ALAMEDA COUNTY  
HEALTH CARE SERVICES

Subject: Fuel Leak Case No. [REDACTED] Unocal Service Station No. 5325,  
3220 Lakeshore Avenue, Oakland, CA

Alameda County Environmental Health (ACEH) staff has reviewed "Ozone Sparge Pilot Test Work Plan" dated November 17, 2005, prepared by TRC. We request that you perform the proposed work and send us the technical reports requested below.

**FIGURE 2**

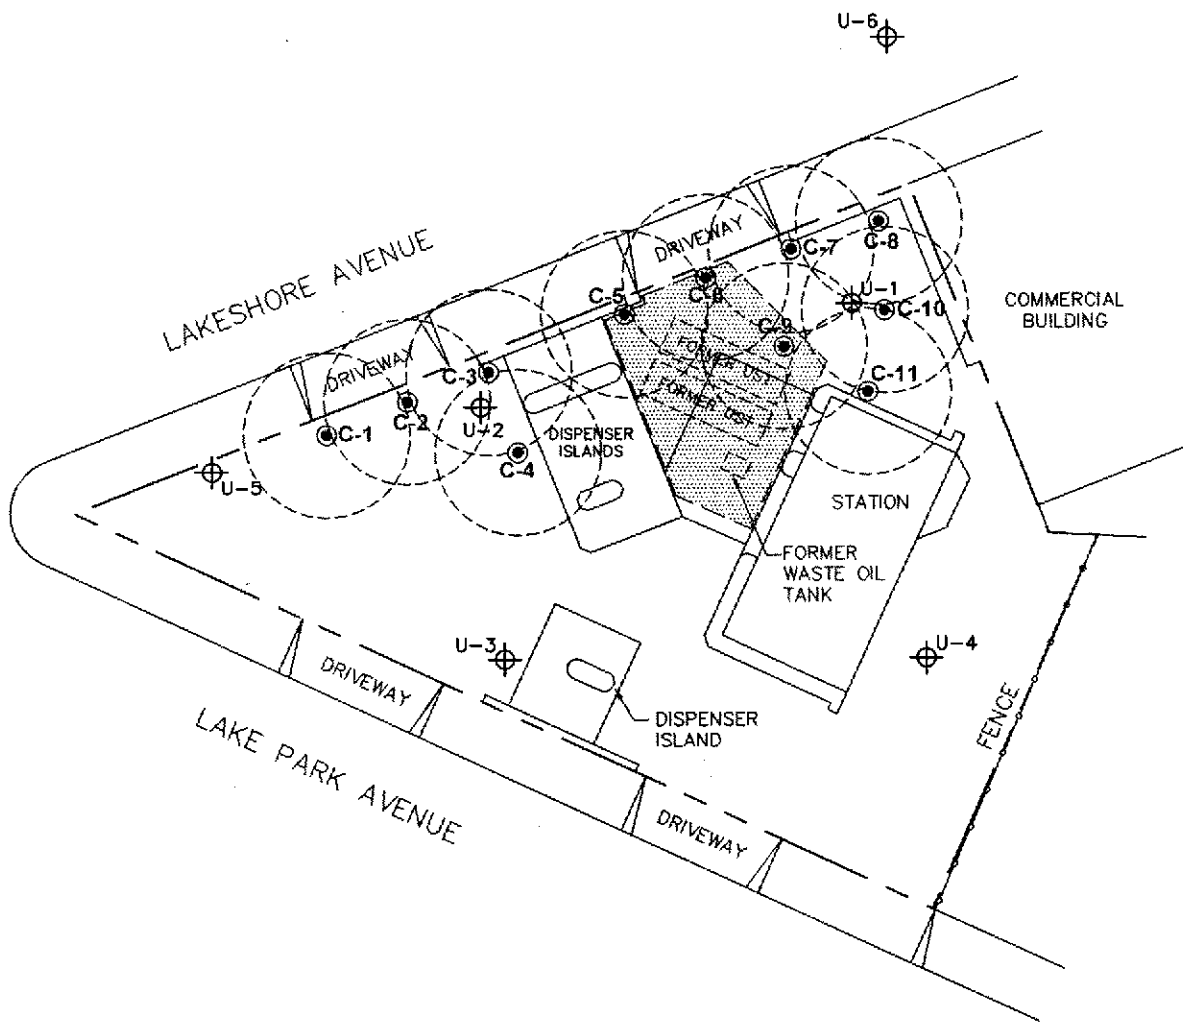
I've reviewed "Work Plan for Interim Remedial Measure/Feasibility Study"

Attached is Figure 2 showing the location of the proposed sparge points and the First Quarter 2005 QMR for the subject site.
